Office Action Summary

10/797,839

BLAKE ET AL.

DETAILED ACTION

FIG. 4

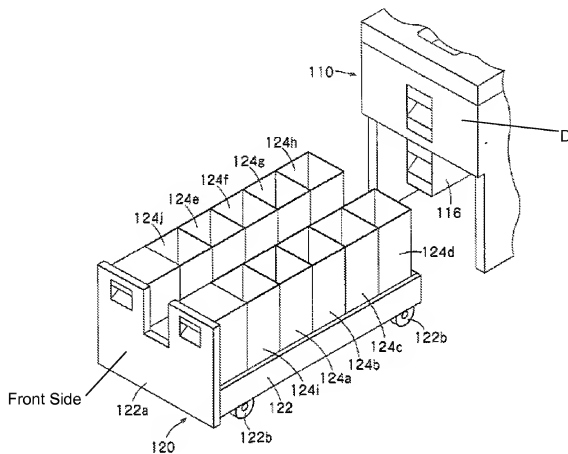
Claim 15: rear side (See FIG. 4 below, D); housing (See FIG. 2, 110);

Claim 16: front side (See FIG. 4 below, D; Note: the location of D can be defined as the rear or front side); housing (See FIG. 2, 110);

Claim 15: rear side (See FIG. 4 below, D); housing (See FIG. 2, 110);

Claim 16: front side (See FIG. 4 below, D; Note: the location of D can be defined as the rear or front side); housing (See FIG. 2, 110);

FIG. G1

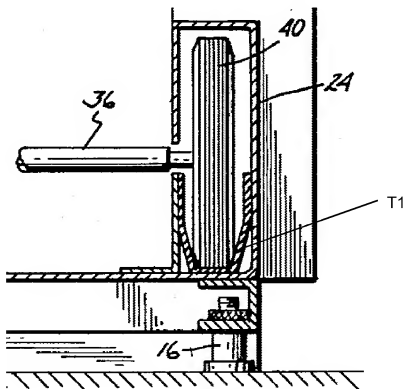
Muellner shows a similar device having a track (see FIG. G1 below, T1) for the purpose of receiving and capturing the casters (column 2, lines 57-66). Therefore, it would have been obvious to a person having ordinary skill in the art at the time the invention to modify Hino as taught by Muellner and include Muellner's similar device having a track for the purpose of receiving and capturing the casters.

Muellner shows a similar device having a track (see FIG. G1 below, T1) for the purpose of receiving and capturing the casters (column 2, lines 57-66). Therefore, it would have been obvious to a person having ordinary skill in the art at the time the invention to modify Hino as taught by Muellner and include Muellner's similar device having a track for the purpose of receiving and capturing the casters.

Muellner shows a similar device having a track (T1 above) for the purpose of receiving and capturing the casters (column 2, lines 57-66). Therefore, it would have been obvious to a person having ordinary skill in the art at the time the invention to modify Hino as taught by Muellner and include Muellner's similar device having a track for the purpose of receiving and capturing the casters.

Muellner shows a similar device having a track (T1 above) for the purpose of receiving and capturing the casters (column 2, lines 57-66). Therefore, it would have been obvious to a person having ordinary skill in the art at the time the invention to modify Hino as taught by Muellner and include Muellner's similar device having a track for the purpose of receiving and capturing the casters.
